Access Compliance Report

Public Rights-of-Way (Curb Ramps)

Intersection ID: 51074	Main Street: HEATHCOTT_CR	Cross Street: SILVER_GLEN_LN	Location: SW
ADA ID: B0F3C2DA1F19	Ramp Type: PerpDiag	Initial Pass/Fail: Fail	Overall Compliance: No
Severity Score: 12.5			
Codes/Mitigation Info/Possible Solution		Field Measurements/Component Compliance

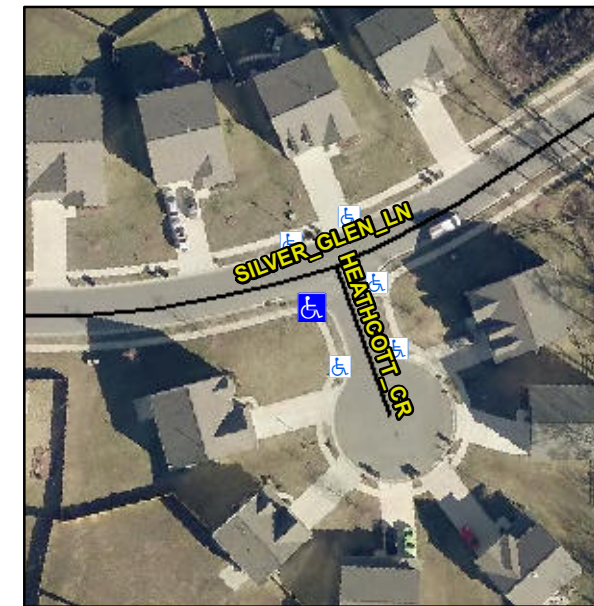
Not Found, R304.2.2

Compliance	Description	Data	Compliance	Description	Data
N/A	Ramp Length (in)	47.0	No	Ramp Slope (%)	10.7
Yes	Ramp Width (in)	48.0	Yes	Ramp XSlope (%)	0.6
N/A	Flare Type LT	N/A	N/A	Flare Type RT	N/A
N/A	Flare Slope LT (%)	N/A	N/A	Flare Slope RT (%)	N/A
N/A	Flare Traversable LT?	N/A	N/A	Flare Traversable RT?	N/A
N/A	Landing Length (in)	N/A	N/A	DWS Provided?	N/A
N/A	Landing Width (in)	N/A	N/A	DWS Contrast?	N/A
N/A	Landing Slope (%)	N/A	N/A	DWS Length (in)	N/A
N/A	Landing X Slope (%)	N/A	N/A	DWS Full Width?	N/A
N/A	Landing Curb? (Y/N)	N/A	N/A	DWS Offset (in)	N/A
N/A	Shared Landing?	N/A			
N/A	Gutter Ponding?	N/A	N/A	Gutter Slope (%)	N/A
N/A	Gutter Lip Ht (in)	N/A	N/A	Gutter X Slope (%)	N/A
N/A	Painted X Walk1?	No	N/A	Painted X Walk2?	No
	X Walk 1 Direction	To E		X Walk 2 Direction	To N
N/A	X Walk 1 Width (in)	N/A	N/A	X Walk 2 Width (in)	N/A
	X Walk 1 Slope (%)	0.5		X Walk 2 Slope (%)	0.0
	X Walk 1 X Slope (%)	2.2		X Walk 2 X Slope (%)	2.6

Remove & Replace Curb Ramp With Two New Directional Ramps or Equivalent.
